ZONING BOARD OF APPEALS MEETING

LOCATION: TOWNSHIP ANNEX, 7527 HIGHLAND ROAD, WHITE LAKE, MICHIGAN 48383
THURSDAY, MARCH 28, 2024 – 6:30 PM

RE: Ginko Self-Storage
Preliminary Site Plan and Special Land Use – Review #4

ORIGINAL ISSUE DATE:
FEBRUARY 2, 2023
DRAWING TITLE
PRELIMINARY SITE PLAN

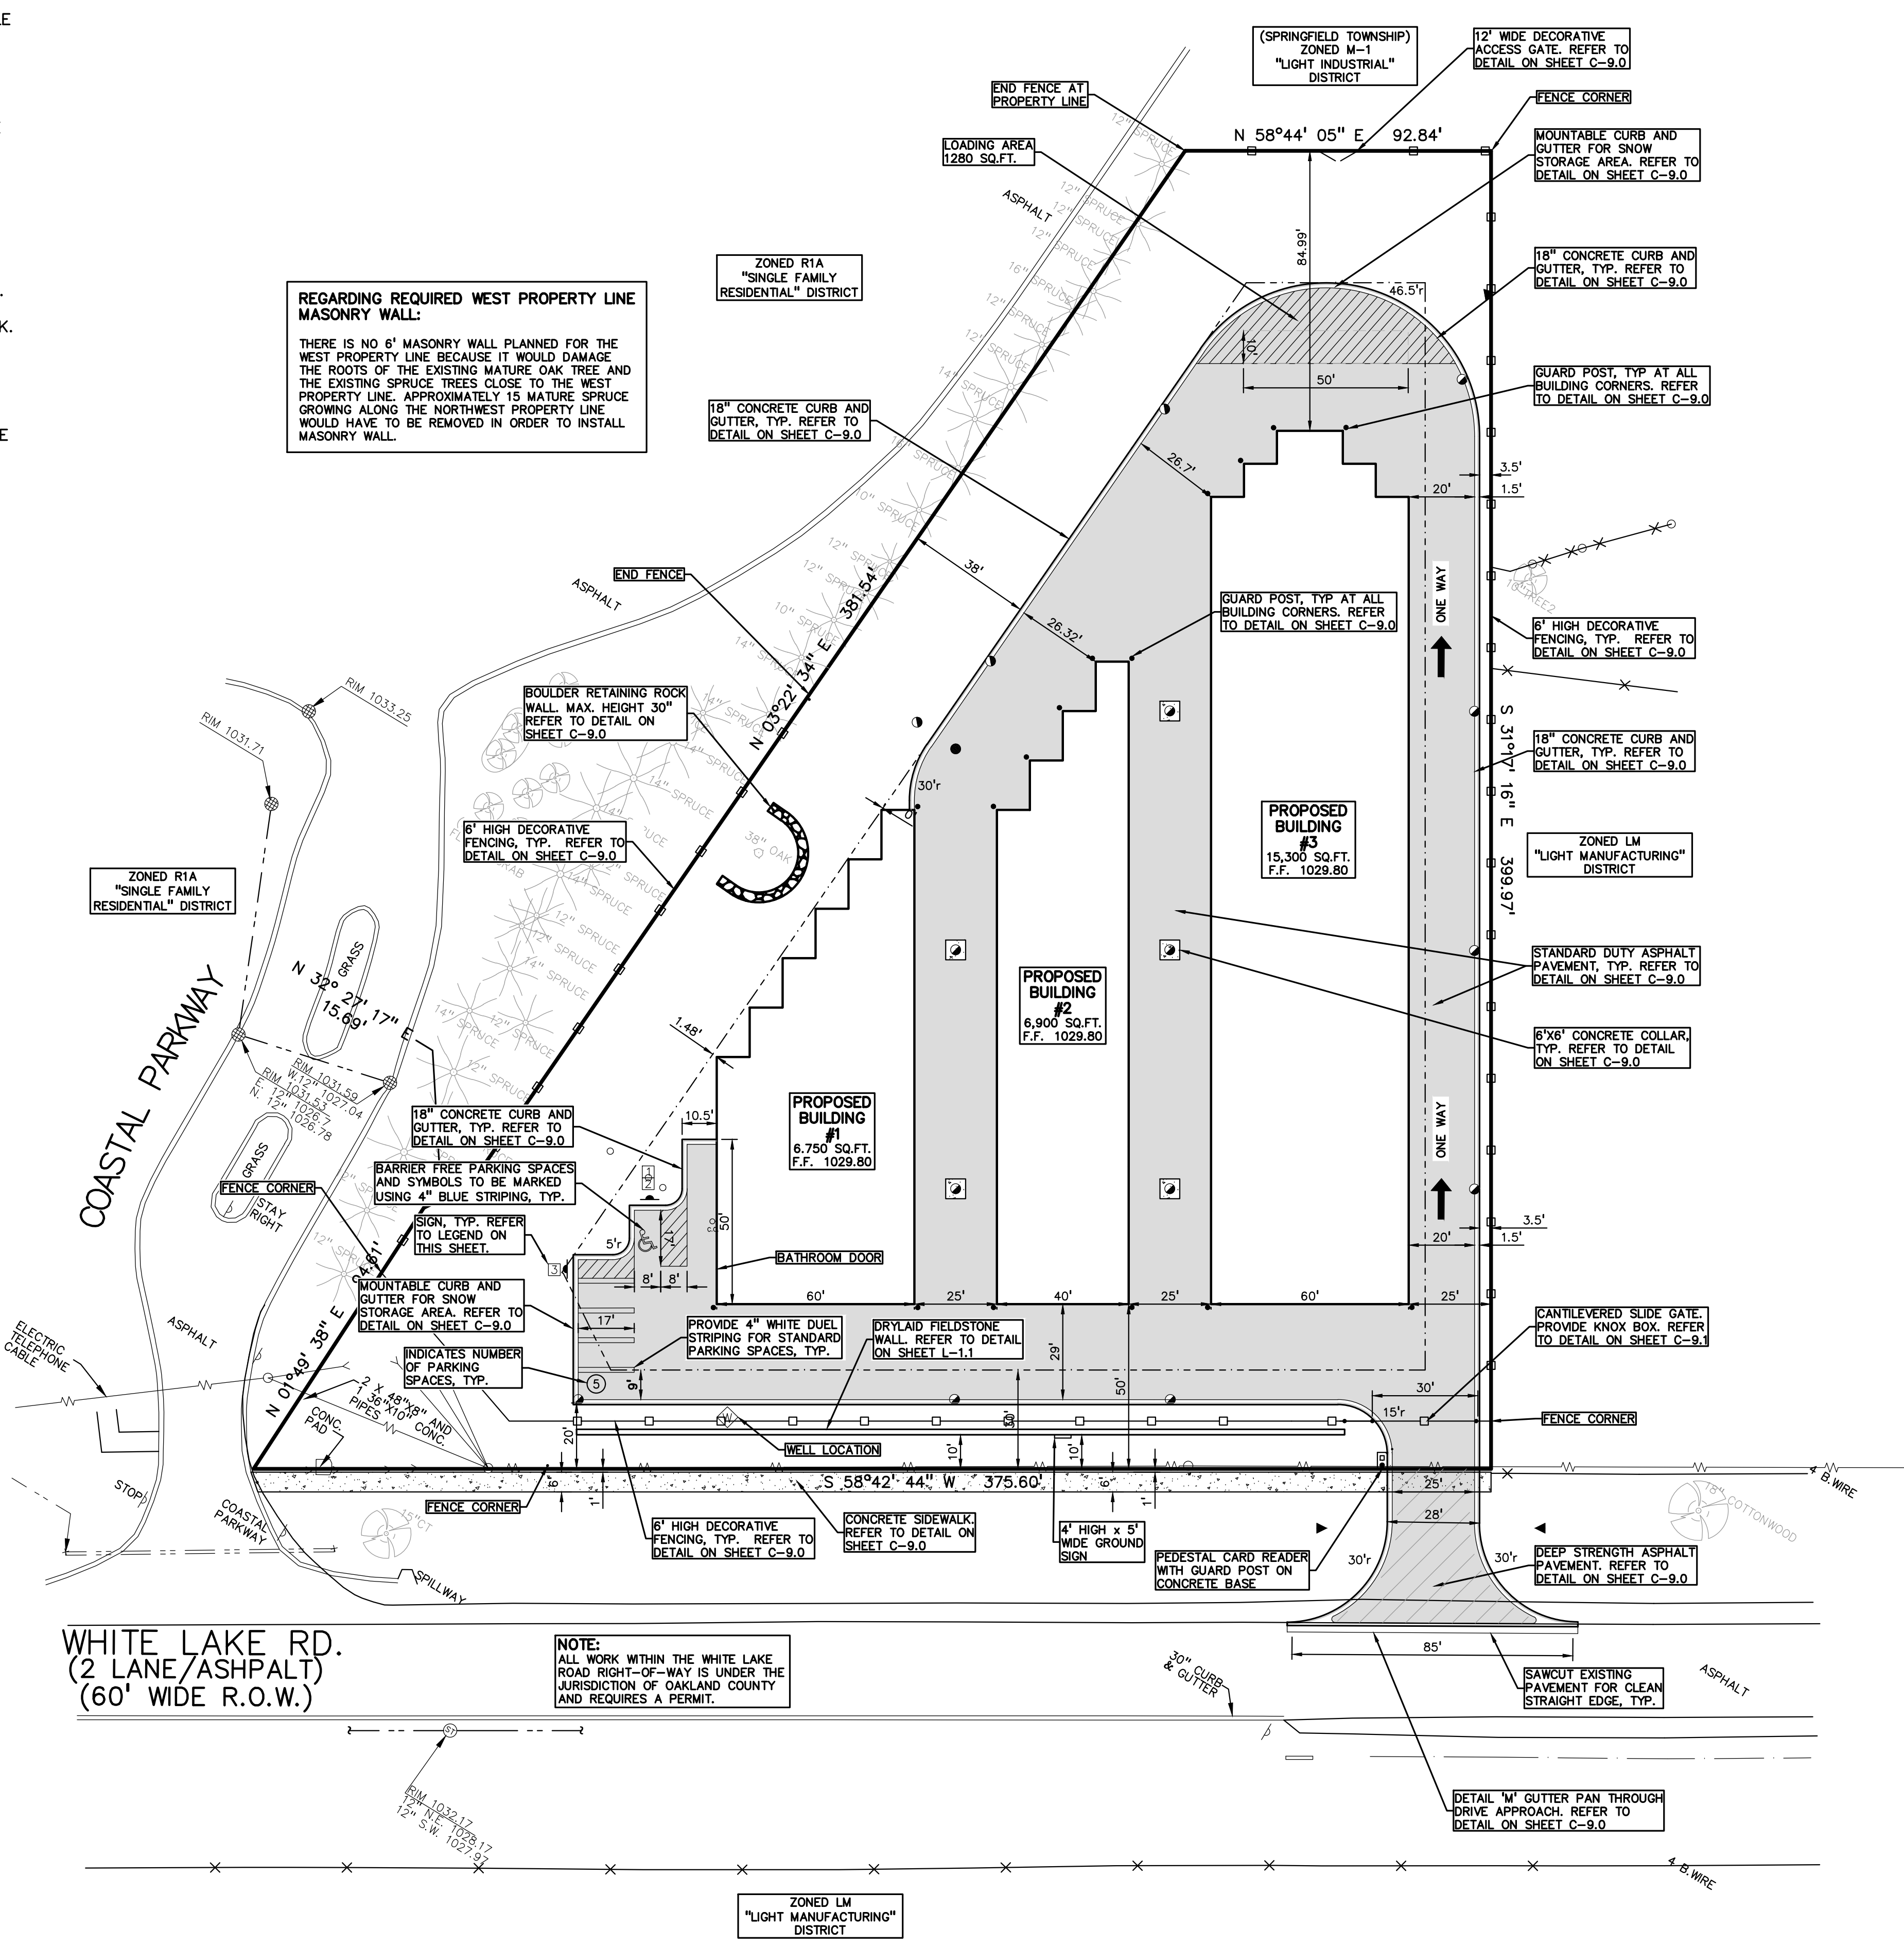
A 28-foot-wide (now 30-foot-wide) cantilevered slide gate is proposed at the driveway (Sheet C-3.1 still shows a 28-foot-wide gate – revise for consistency). (Comment addressed. Sheet C-3.0 shows the gate is 30-foot-wide; the 28-foot dimension noted on Sheet C-3.1 is the dimension of the access drive from back-of-curb to back-of-curb (25-foot-wide drive aisle provided between edges of the gutter pan). **Gated vehicular access is subject to review and approval by the Fire Department, and a permit is required from the Building Official.** (Comment remains as a notation. Gate details/specifications shall be provided at final site plan).

Sheet C-3.1 shall be revised to demonstrate how a fire truck will access Building 1 (via the drive aisle east of Building 1 and west of Building 2?). Can a 40-foot-long truck driving south via the aforementioned access aisle make an east/west turn? (Comments outstanding). (Comments addressed. Sheet C-3.1 has been revised to show the requested turning movements). Pursuant to the zoning ordinance, designation of fire lanes is required at preliminary site plan.

The proposed west side yard setback (drive aisle/maneuvering lane) is 25 feet. If a 38-foot greenbelt is not provided, a variance is required from the Zoning Board of Appeals. (Comment addressed. A 38-foot setback from the west property line has been proposed).

DRAWING TITLE
PRELIMINARY LANDSCAPE PLAN

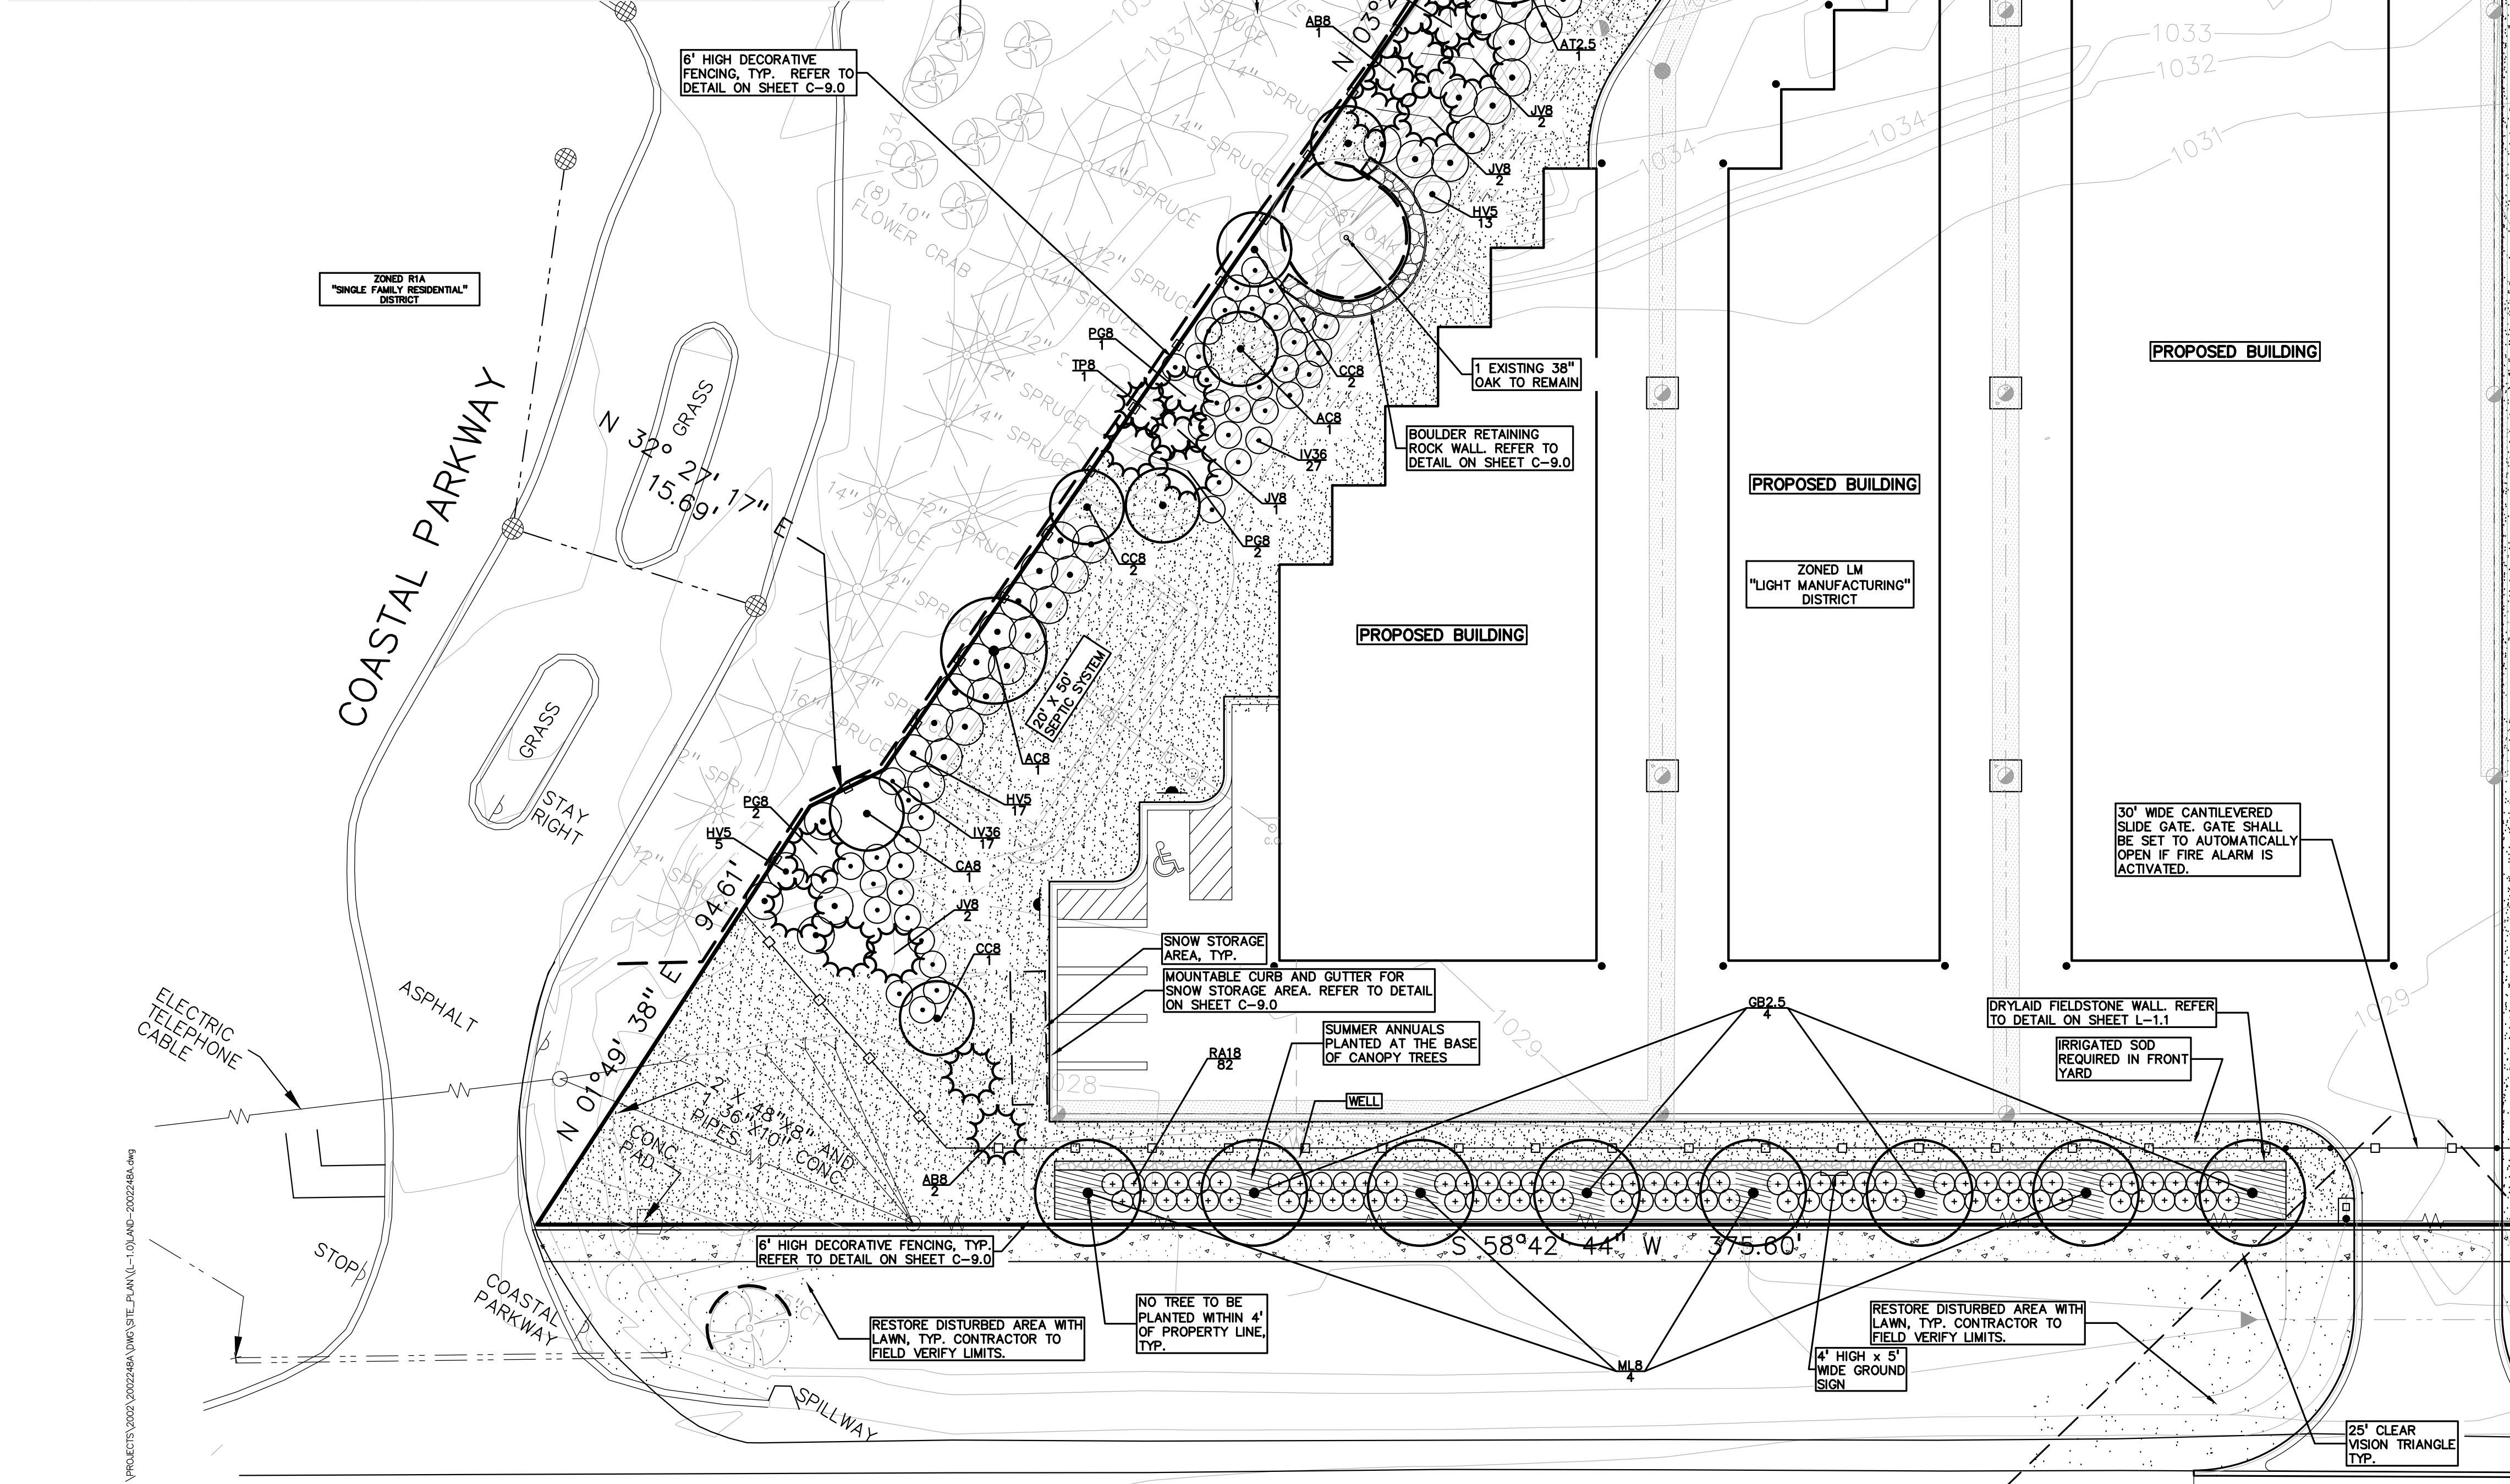
- **See comment on previous page regarding required greenbelt along west property line. (Comment addressed. A 38-foot setback from the west property line has been proposed).**

- **47 trees are required for interior landscaping and 33 new trees are proposed. The landscape calculations indicate 48 trees are being counted as interior landscaping. Existing trees on the site being counted towards interior landscaping shall be identified on the plan. Off-site trees shall not be counted as interior landscaping for the proposed self-storage facility. (Comment outstanding. Greenbelt landscaping adjacent to the road right-of-way is being counted as interior landscaping. Therefore, the proposed amount of interior landscaping is deficient and requires a variance from the Zoning Board of Appeals. An extensive land form buffer (six-foot berm landscaped in accordance with the ordinance) is required adjacent to the road right-of-way, but not proposed; therefore, a variance is required from the Zoning Board of Appeals). (The Applicant's engineer stated a variance will be requested).**

- **An extensive land form buffer (six-foot berm landscaped in accordance with the ordinance), or, a land form buffer (three-foot berm landscaped in accordance with the ordinance) AND a six-foot masonry screen wall (landscaped in accordance with the ordinance) are required along the west property line. If not provided, a variance is required from the Zoning Board of Appeals. (Comment outstanding. A variance is required from the Zoning Board of Appeals). (The Applicant's engineer stated a variance will be requested).**

- **Cyclone fencing should not be permissible and shall be removed from the plan. Remove the chain link fence detail and the chain link access gate detail from Sheet C-9.0. A different fencing type may be proposed for consideration.** (Comments addressed. A decorative fence (non-obscuring) has been proposed. At final site plan, the Planning Commission shall determine if non-obscuring fencing is acceptable. Also, the Applicant shall clarify why decorative fencing has not been proposed around the entire property (no fencing at northwest portion of the property).

- **No more than two planted trees in a row shall be of the same species.** (Comment outstanding. Three Eastern Red Cedar trees are planted in a row along the west property line). (Comment outstanding. Three white spruces in a row are now proposed along the west property line). (Comment addressed. The landscape plan has been revised accordingly).
